Subject: Issue with M/s BTIPL make three phase drive propulsion equipment

Ref.: CLW letter no. C-D&D/T/24, Vol-VII dated 17th Mar 2021

In reference to the subject, we would like to update following status for issues reported for IGBT based 3-Phase Drive propulsion Equipment.

Annexure 1: Procedure to edit Energy Parameters

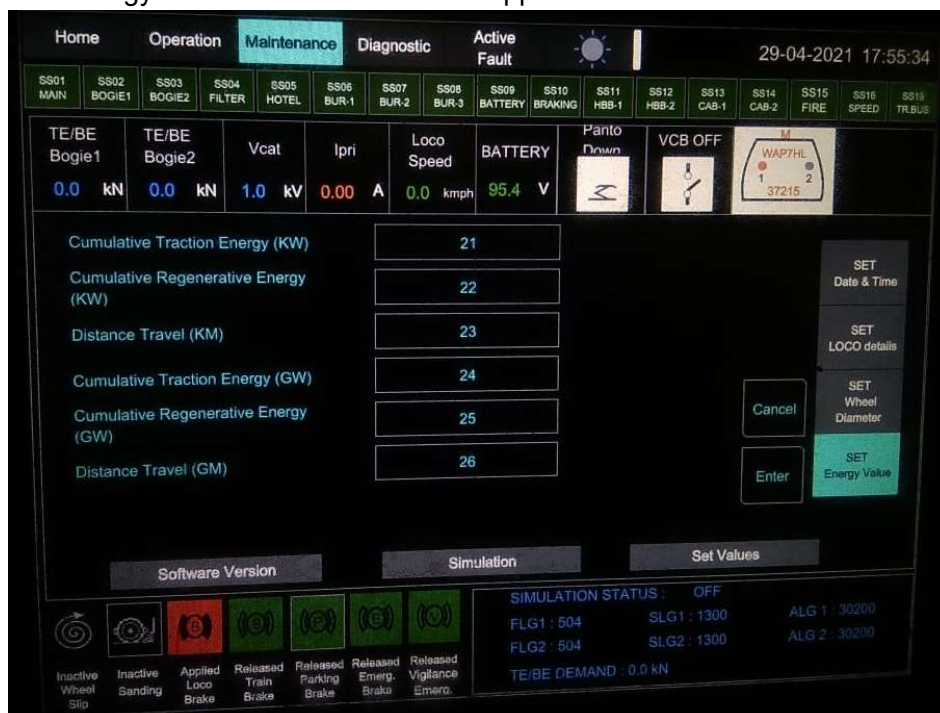
l	Energy parameters for setting is not editable.	Energy parameters are editable according to Annexure-1 procedure.

We have provided a provision to edit Energy parameters on DDU and values set can be observed on DDU only.

Go to Maintenance screen and type Password 654321 and press Enter.
